Original Rev for Memco

Took T3-8180 design rev14 and reworked it for PWM project

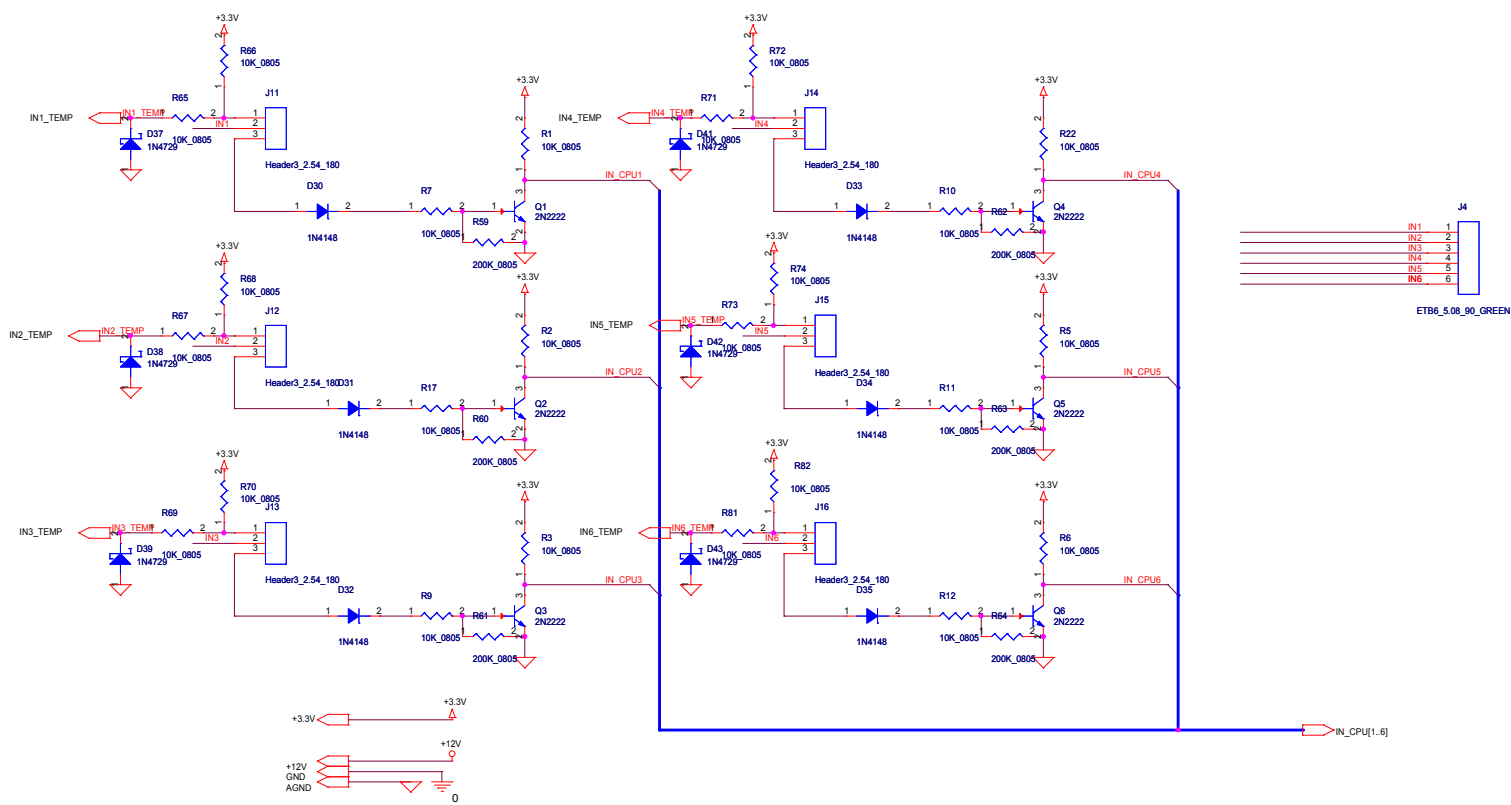
Done: rectify connection with Input Con. Was mis-labelled

Done: change cap by op-amp to 10uF. 100uF too slow

Done: fix footprint of switches

TBD: rectify footprint names of 2N2222, Q1, Q2 for BOM purposes

[Slick Screen on Board was mislabelled. Still reads Rev2](#)
[note: make sure muxes are phillips brand. Does not work with Texas chips](#)
